MINUTES OF THE REGULAR MEETING OF THE PLAN COMMISSION, VILLAGE OF TINLEY PARK, COOK AND WILL COUNTIES, ILLINOIS

ITEM #1: WORKSHOP – BRADY GILL FUNERAL HOME ADDITION, 16600 OAK PARK AVENUE – SPECIAL USE FOR A DWELLING ABOVE A PRINCIPAL USE AND SITE PLAN/ARCHITECTURAL APPROVAL

PLAN COMMISSION STAFF REPORT

Brady Gill Funeral Home Addition

Existing Conditions & Removal Plan

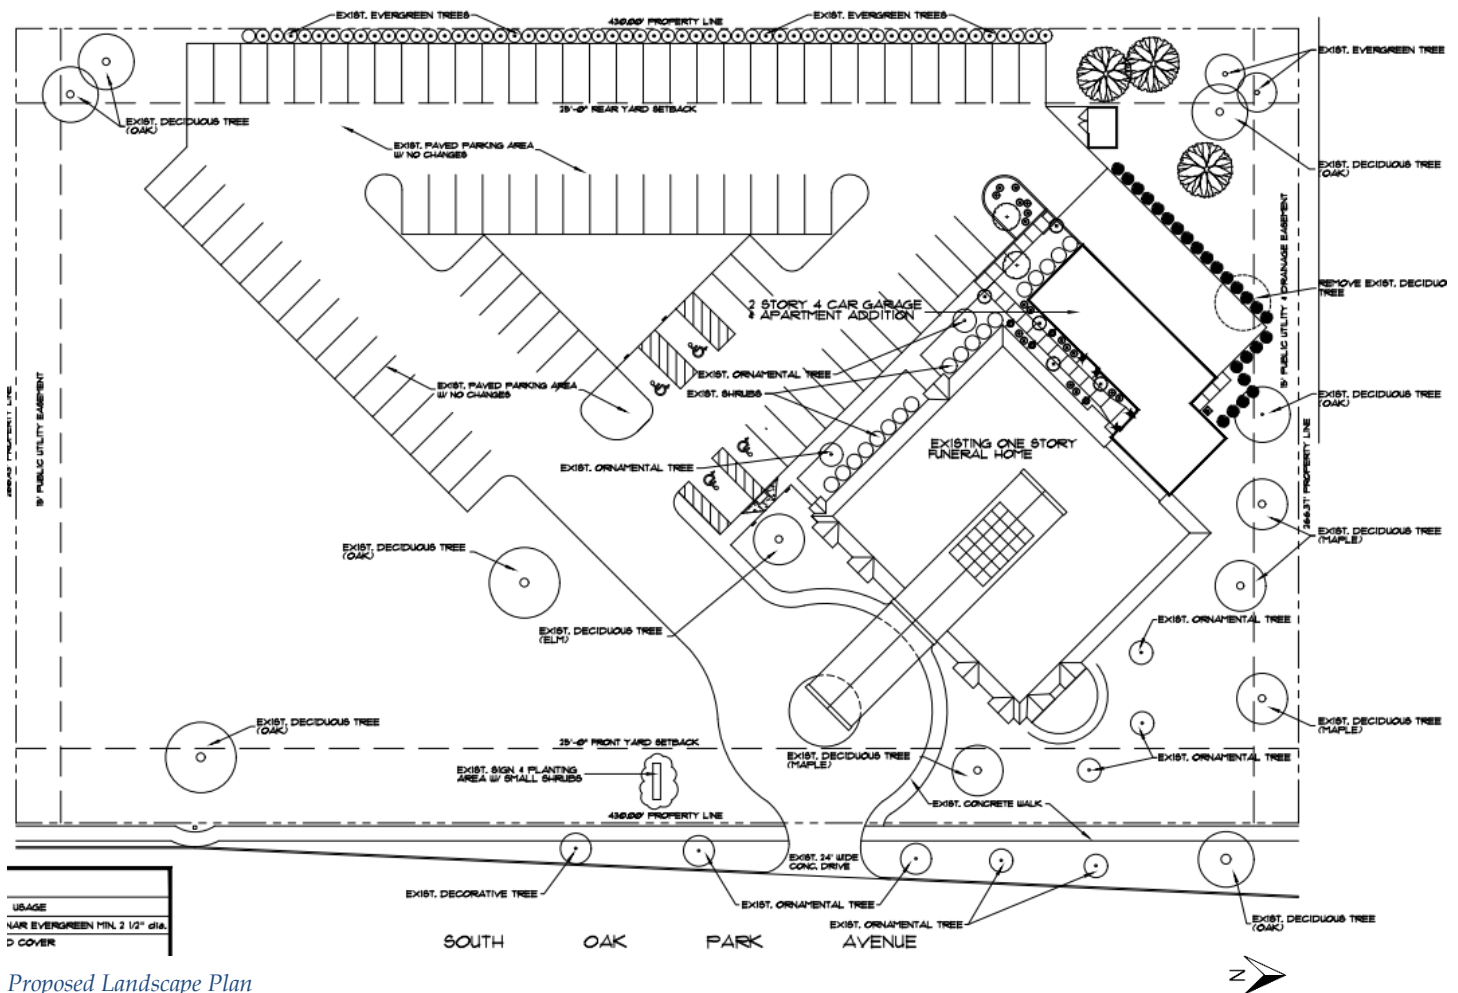
The engineering Existing Conditions & Removal plan shows the removal of the existing driveway access, asphalt for the construction of the proposed peninsula, and trash enclosure. The plan also shows a 6' wide removal and restoration for sanitary installation within the parking lot, and concrete walk removal and replacement for handicap ramp installation. According to the Site Development Data on the engineering Geometric Plan, the proposal has a +2,849 sq. ft. change in impervious surface. The Village Engineer has reviewed these submitted preliminary plans,

and the Site Plan/Architecture approval will be conditioned on final engineering approval of the drawings. The Petitioner has also submitted plans to MWRD, who has noted that a WMO permit will be required. Permit approval by the Village will require MWRD approval.

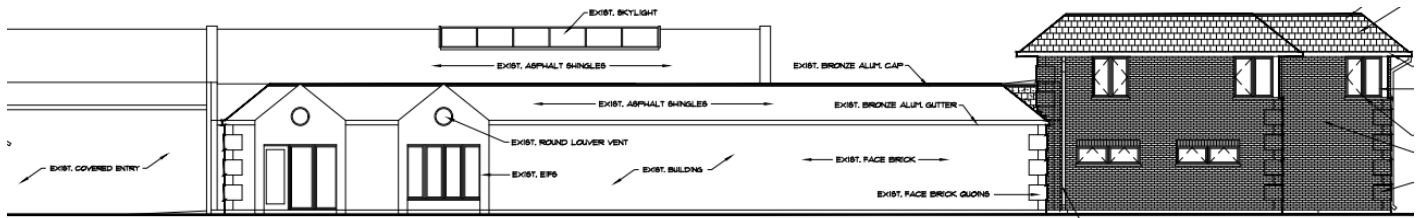
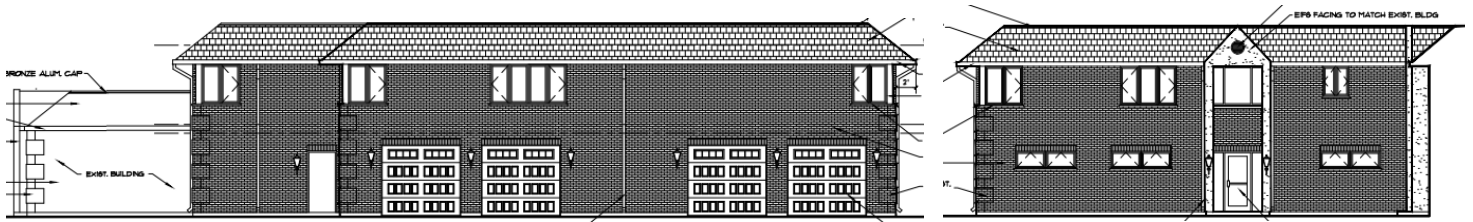
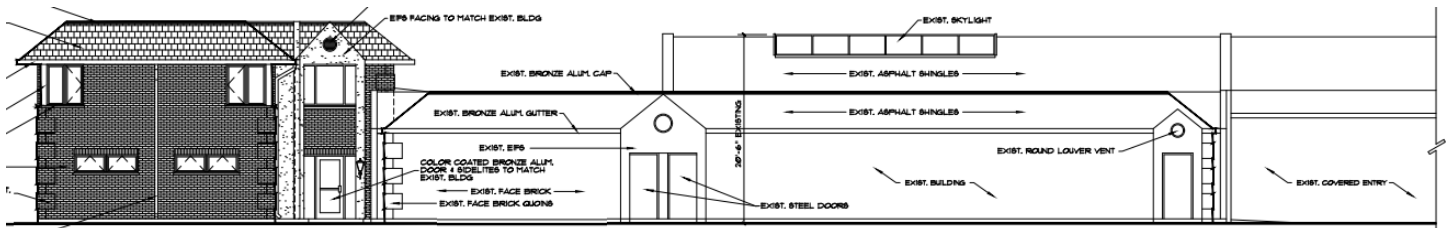
Lori Kosmatka, Associate Planner showed the elevations. She noted there are entryways identified with a decorative peak. The Petitioner's original proposal had the entire entryway as EIFS material, but now there is brick in the middle.

The Petitioner's architect stated the reason for originally wanting EIFS between the windows and the door is that it appears to be more delicate. He feels the brick looks more massive for the entry.

The currently proposed courtyard entries have a decorative peaked front gabled EIFS structure with short wing wall extensions, and brick between the top of the first floor's door and the bottom of the second floor's window. The EIFS wing walls extend two stories up, with the peaked gable at the second floor. The Petitioner proposes this

The Petitioner originally proposed the entries to be entirely EIFS, but added the brick in the middle per Staff request. The Petitioner's architect believes that if the EIFS were continuous, it better matches the existing architectural EIFS treatments. However, Staff feels that if the EIFS were to be continuous without the brick or other break in material, it appears monolithic and out of scale. The existing EIFS entries adjacent to the addition are only one story. There are a couple other minor but notable new architectural elements. The new four steel garage doors will have a row of tinted windows and brick soldier coursing above. The second story corner windows will have corner wood columns (6"x6") wrapped in color coated bronze aluminum to match the existing building.

Open Item #3: Discuss the compatibility and appropriateness of the building addition's design and materials as it relates to the existing building and its location on the site. Consider approval be conditioned by physical material samples being provided during the permit process for staff review and approval.

COMMISSIONER GATTO noted she understood. She stated it (current proposal) looks great. She had no further questions.

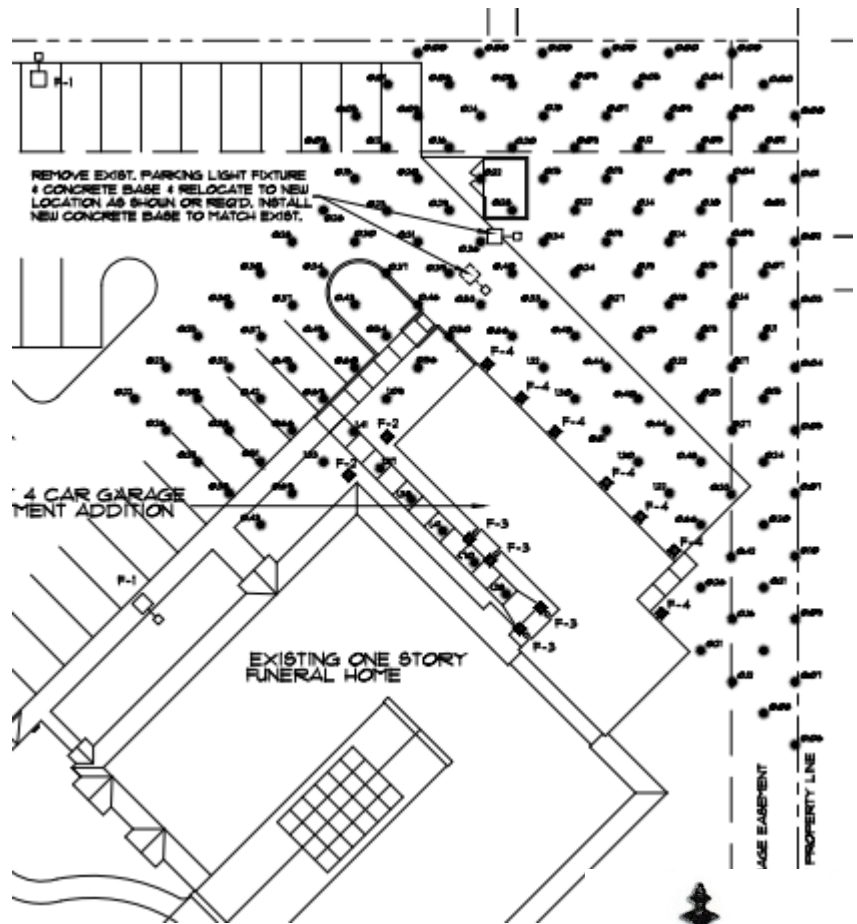
The Petitioner has provided a lighting plan showing photometric calculations for proposed lighting as it affects the area surrounding the proposed addition. Importantly, the Petitioner demonstrates that the maximum foot candles proposed is only 0.10 fc at the north property line and 0.00 fc, at the west property line.

The architect’s plans indicate 0.10-foot candles at the property line abutting nonresidential (north) and zero foot candles abutting residential (west), which meets the Zoning Ordinance’s maximum requirements. The code regulates that property line foot candles adjacent to nonresidential properties be maximum 2.0-foot candles, and maximum 0.10 foot candles to residential.

Open Item #4: Discuss placement and style of the proposed lighting.
